REMARKS

The Examiner's Office Action of 4/29/04 has been reviewed.

FIG 4

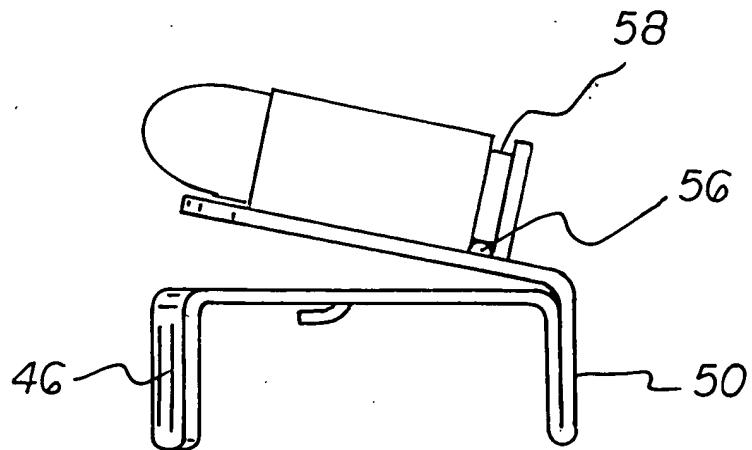
The Examiner objected to the drawings "because lead line 54 (supplemental bend) does not extent to the bend between upwardly extending portion 50 and inwardly extending portion 52 (see fig. 4)." Drawings corrections are submitted herewith, one sheet showing the corrections in red plus a replacement sheet. The lead line for reference numeral 54 now extends properly to the bend between upwardly extending portion 50 and inwardly extending portion 52. Fig. 4 has further been corrected to properly show follower 42.
